Based on the information submitted by your letter dated October 29, 1984 we have concluded that your Model 41574 Series Backscatter gauge design is acceptable for licensing purposes in accordance with the conditions of the attached certificate of registration.

DATE	SCALE: 1:1; 2:1	DATE: 2-15-84
APP'D.	DRAWING NUMBER	
41574/9'00-02 E

SSD EVALUATION TRACKING SHEET

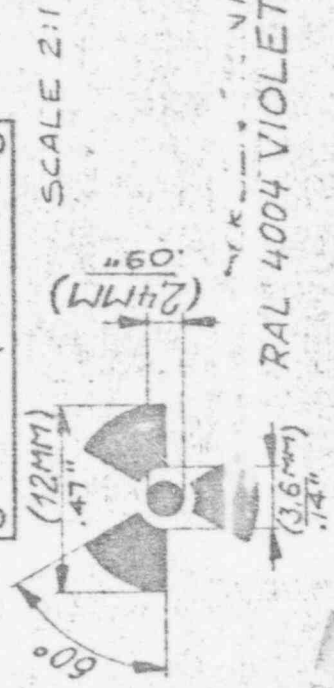
Label appears to comply with
Section 20.203, 10CFR Part 20

A facsimile of label would
be useful -

color : yellow

symbol ?

Method of Attachment.
